Discussion on 70/80 GHz Report & Order (FCC-03-248)

December 11, 2003

Cisco Systems, Comsearch, Endwave,
LOEA Communications, Terabeam

Overview

Spectral Efficiency

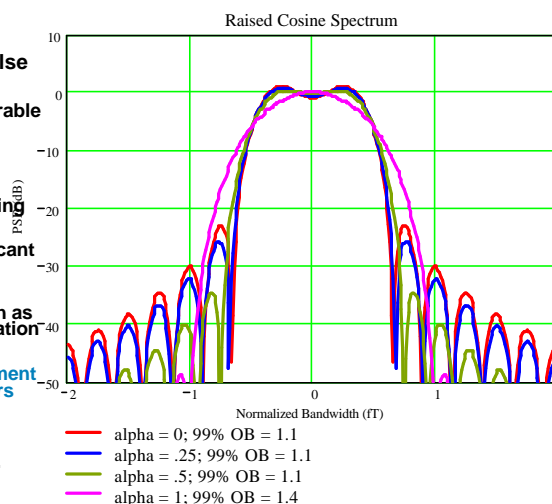
- The figure illustrates the spectral occupancy with raised cosine pulse shaping.
 - For low barrier to entry, it is desirable to implement simple modulation schemes.
 - The requirement of a minimum spectral efficiency of 1 bps/Hz prohibits the use of binary signaling such as OOK and BPSK.
 - Even QPSK would require significant pulse shaping to reduce the 99% occupied bandwidth.
 - If channel coding is desired, such as rate = 1/2, then high order modulation schemes would be required.
 - **Conclusion: the 1bps/Hz requirement is onerous for radio manufacturers**
- All simulation results presented herein assume completely co-channel and overlapping signals. Band segmentation has limited incremental value.

ATPC Hub-and-Spoke Simulation Results

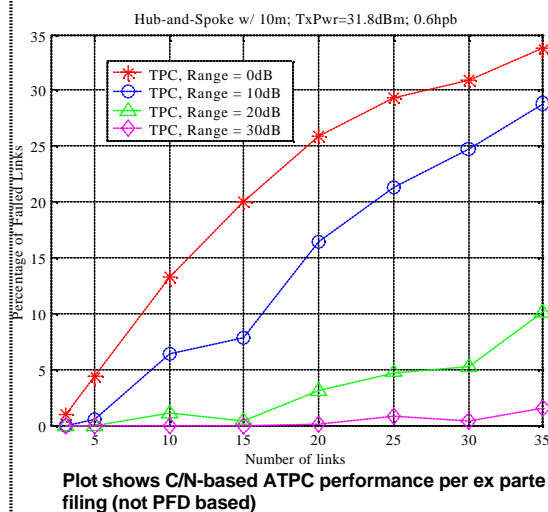
- This figure illustrates the effect of ATPC range on the control of harmful interference
 - Interference is problem when a short-range link is on adjacent "spoke" to long-range link
 - Rain fading severely attenuates long-range link's signal
 - ATPC keeps short-range link transmitter's at lowest possible level, mitigating interference
- The percentage of failed links dramatically decreases as the ATPC dynamic range increases
 - JRC proposed max ATPC range of 32dB corresponding to 55-dBW EIRP transmitter
